1963 - 1964 Corvette: Service News: Air Conditioning Changes

Subject: Air Conditioning Changes
Model and Year: 1963 - 1964 Corvette
Source: Chevrolet Service News
Date: March 1964 - Volume 36 - Number 3

Fig. 1—Rework of Blower Motor Circuit

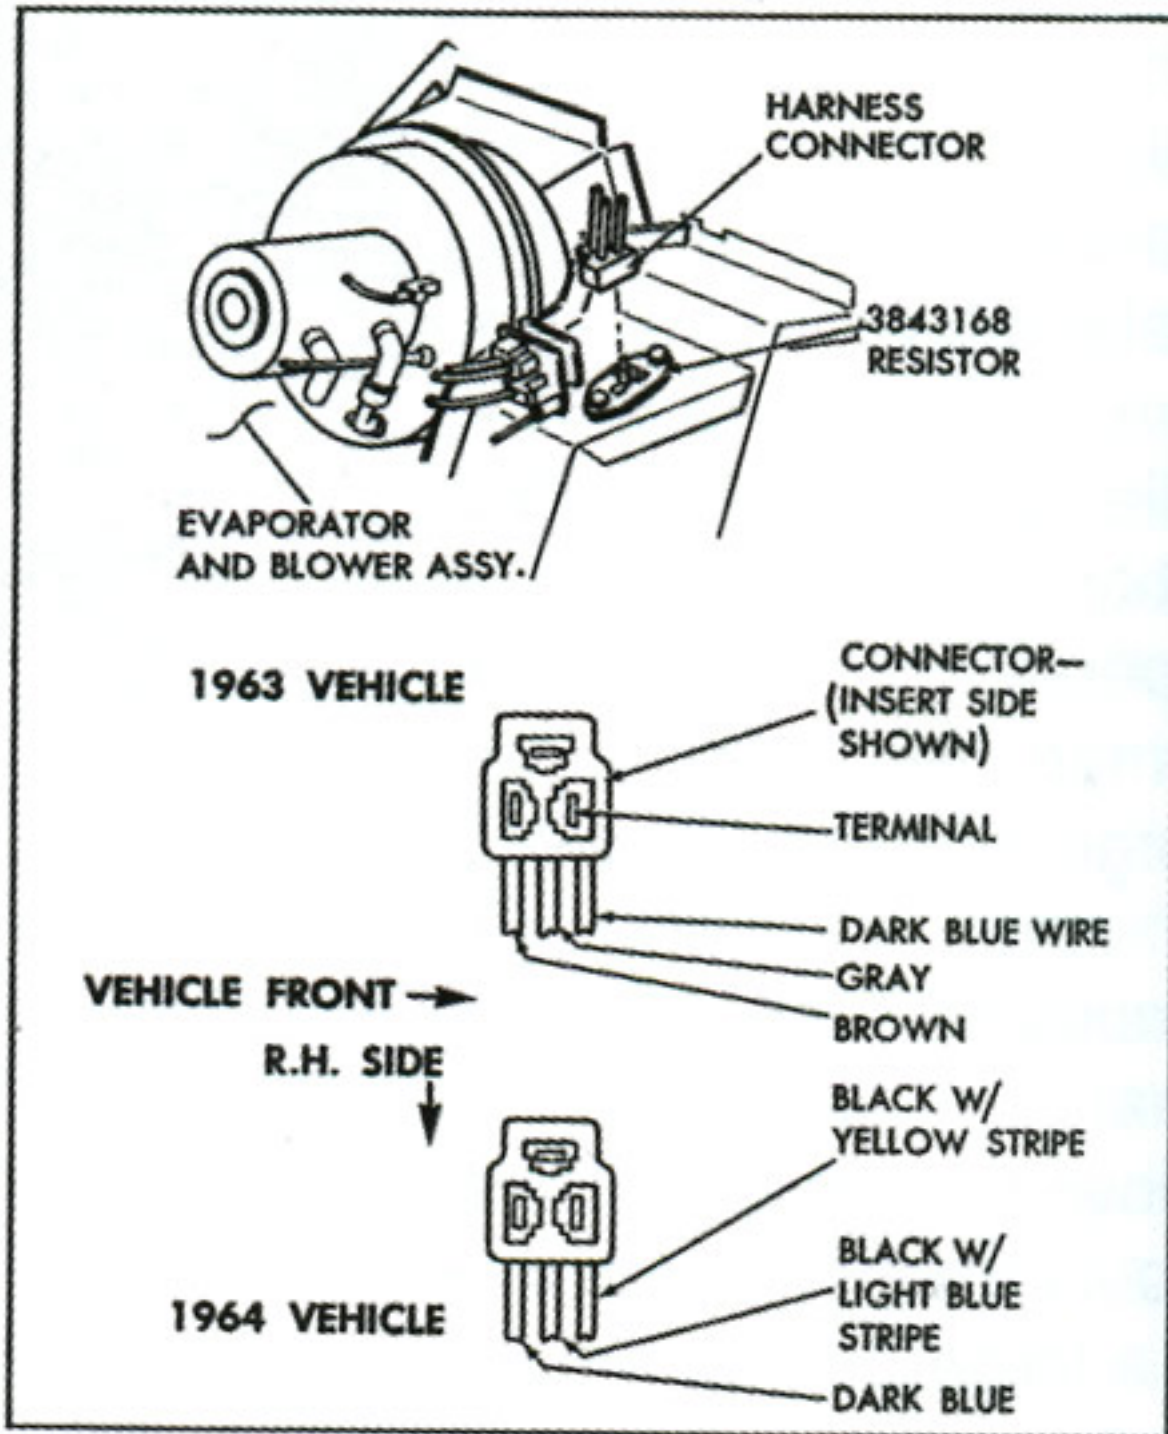
On all 1963 and early 1964 Corvettes equipped with Air Conditioner RPO C60, it would be necessary to slightly modify the electrical circuit to provide a true medium blower speed for the heater. In these RPO C60 installations, the resistor that was used in the blower motor circuit to establish blower medium and low speeds, unfortunately, during heater operation provides blower "low" RPM at the MEDIUM as well as at the LOW speed setting of the operator's control lever.

A wiring change introduced in Production averted the above problem on vehicles built later than December 16, 1963.

To provide the desired medium blower speed, on the earlier production units, proceed as follows:

1. Replace the installed blower motor resistor with Resistor Part No. 3843168.
2. Reverse the location of two leads in the multiple connector that plugs into the blower motor resistor assembly; reinstalling the color coded leads in the connector body at the locations show in Fig. 1.

NOTE: To remove the terminals from the connector body, insert a small screwdriver along the inboard side of the terminal and move the end of the screwdriver outboard to disengage the terminal from the locking ledge in the connector. Before reinstalling the terminals in the connector, spread the

terminals to insure that they lock securely when installed.
